**COMMITTEE OF THE WHOLE SEPTEMBER 15, 2003**

**ZONING BY-LAW AMENDMENT FILE Z.03.060  
SITE DEVELOPMENT FILE DA.03.034  
PROMENADE PARK LIMITED**

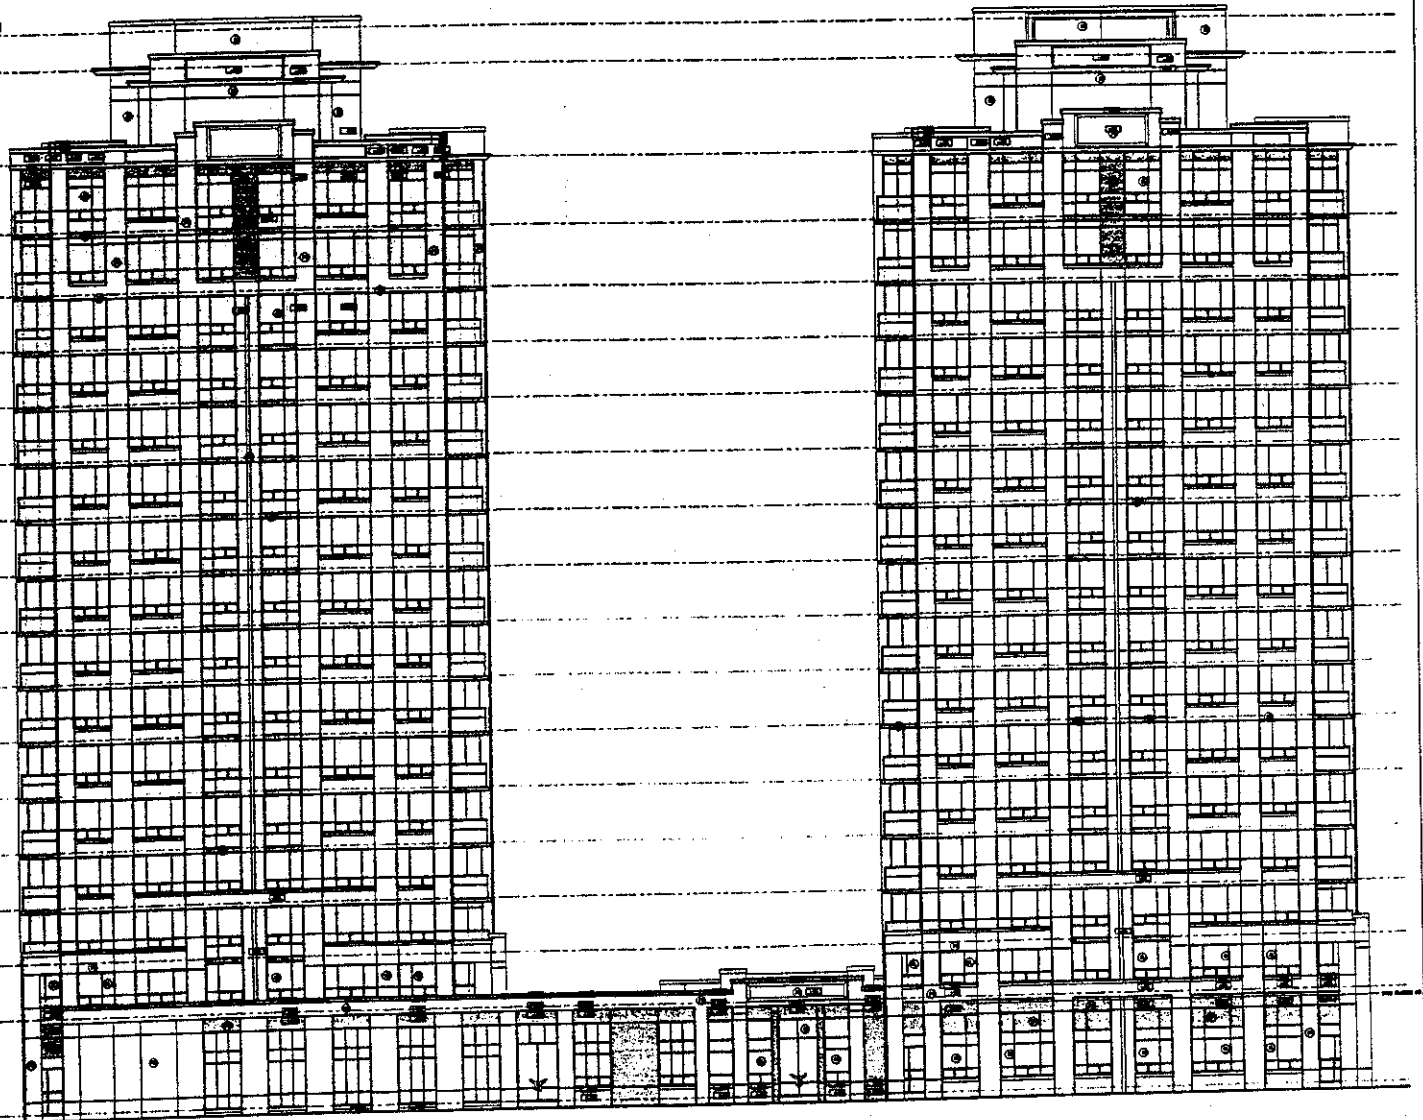
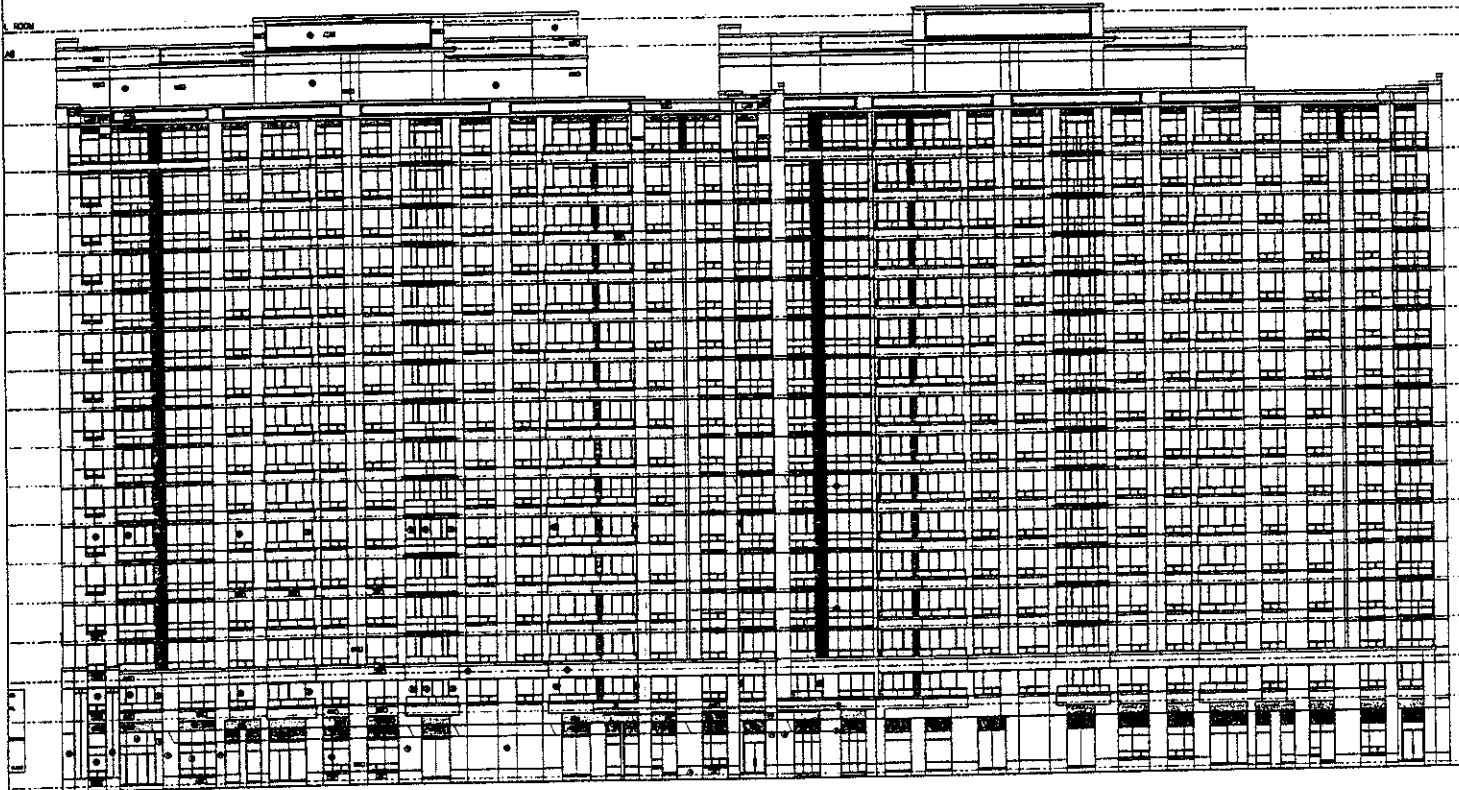
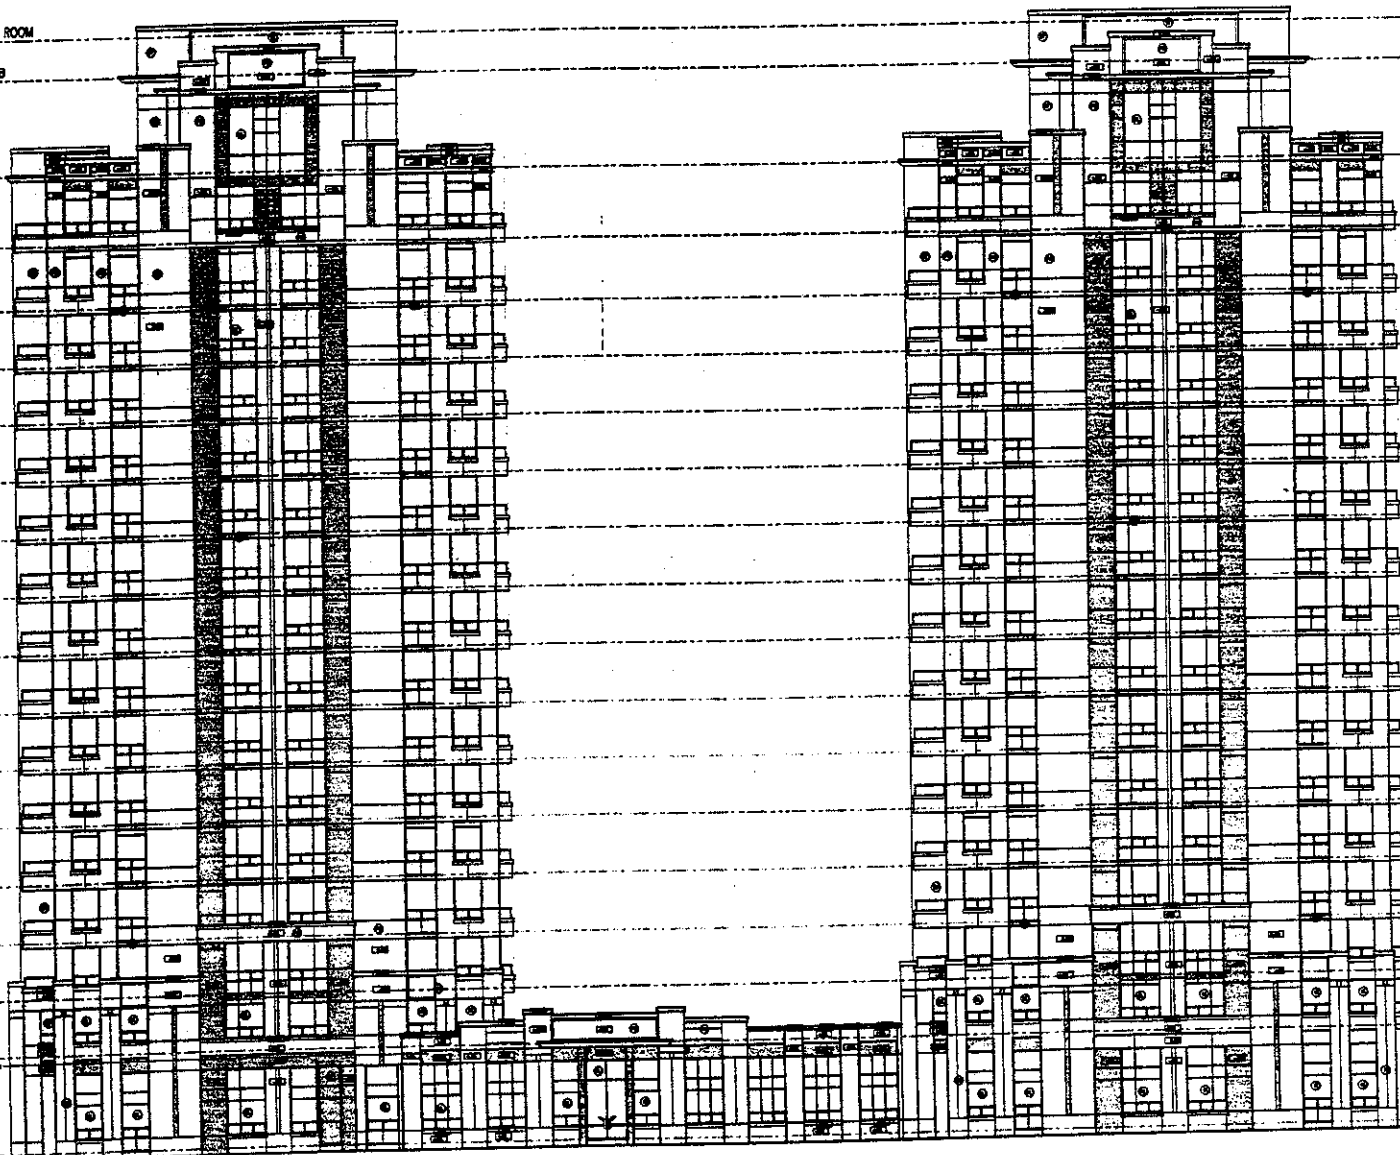
“The Urban Design Department would like additional emphasis placed on the podium of each building beyond what is shown in the elevation drawings, either through increased horizontal projection of the podium and/or an articulated architectural treatment that reinforces human scale aspects of the development and provides visual interest as a whole.”

All roof-top mechanical equipment will be screened from Promenade Circle, West Promenade, and New Westminster Drive, and all service doors and garbage enclosure doors, including the doorframes, are to be painted to match the stucco façade. The final elevations shall be to the satisfaction of the Commissioner of Planning.

# Landscape Plan

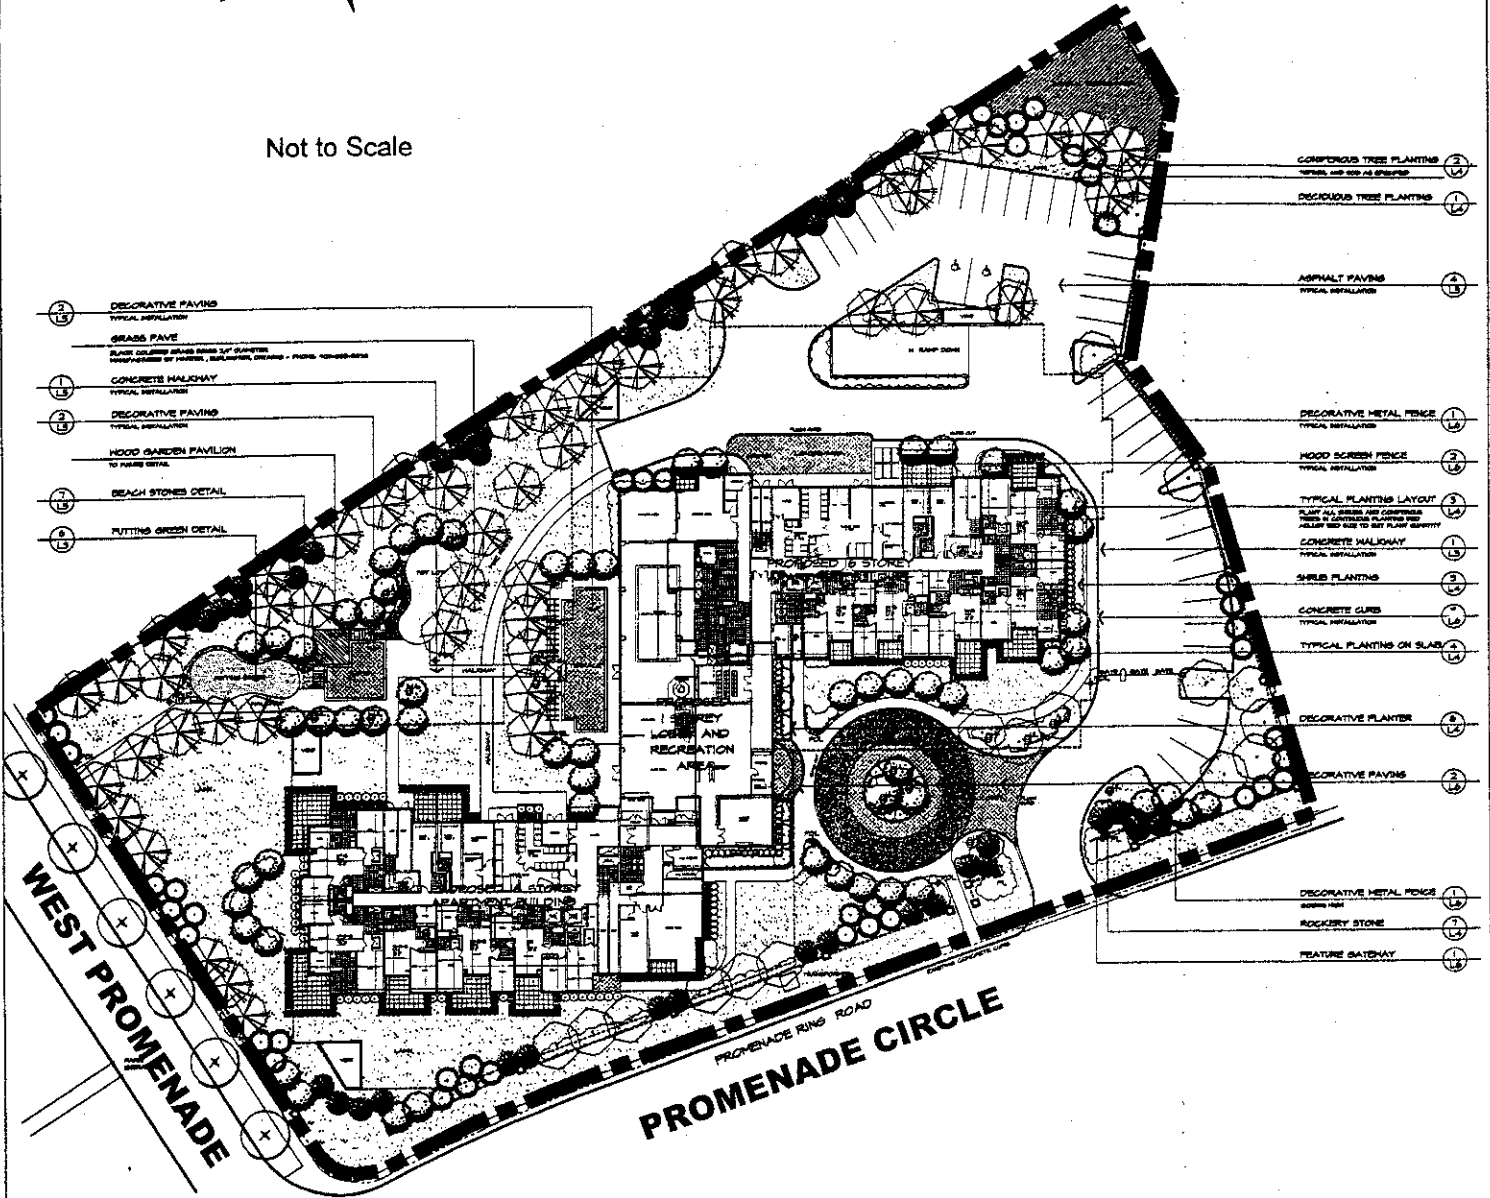
The site plan, landscape plan, and elevation drawings were circulated for comment to all area residents who had requested notification. To date, one comment has been received to upgrade the fence detail along the north property line from black chain link to decorative metal fencing. The landscape plan has been revised to show this change.

The plan shows a 1.6m high decorative metal picket fence with precast concrete piers along the north, east, and south property lines, and a 1.8m high existing wood privacy fence along the west property line.
